06-164r2 SAS-2 Require expanders transmit three AIPs

To: T10 Technical Committee
From: Rob Elliott, HP (elliott@hp.com)
Date: 14 May 2006
Subject: 06-164r2 SAS-2 Require expanders transmit three AIPs

Figure 1 — Extended primitive sequence

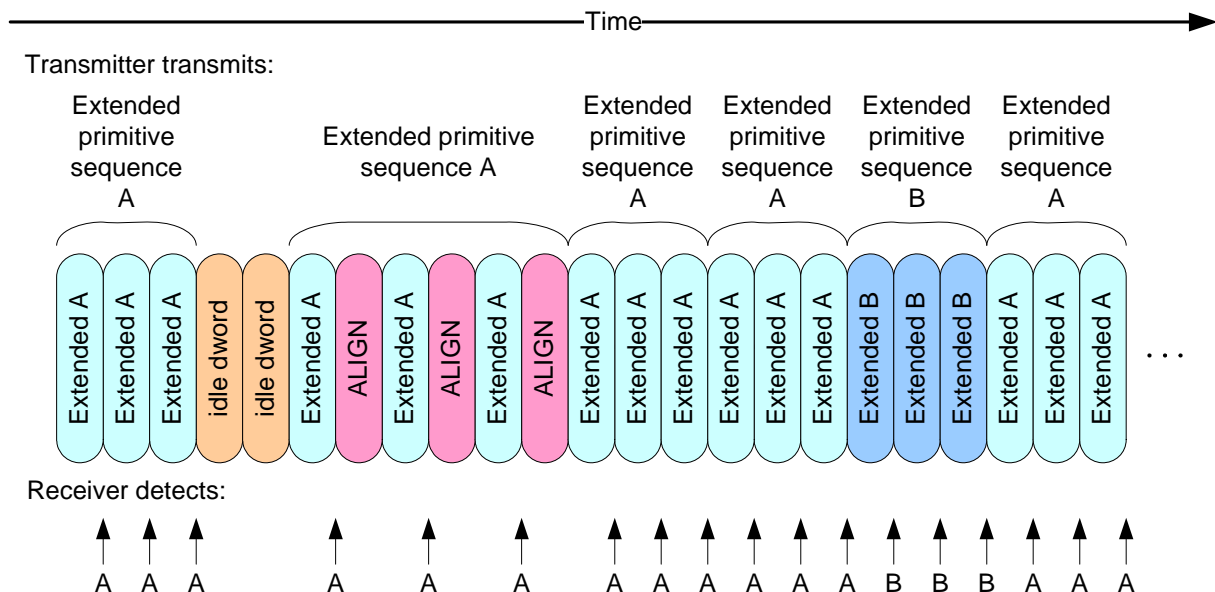
[7.2.4.x Extended primitive sequence](#)

[Primitives that form extended primitive sequences \(e.g., AIP\) shall be transmitted three times consecutively. ALIGNs and NOTIFYs may be sent inside primitive sequences as described in 7.2.4.1.](#)

[A receiver shall detect an extended primitive sequence after the primitive is received one time. The receiver shall process an extended primitive sequence the same as a single primitive sequence \(see 7.2.4.2\).](#)

[Figure 1 shows examples of extended primitive sequences.](#)
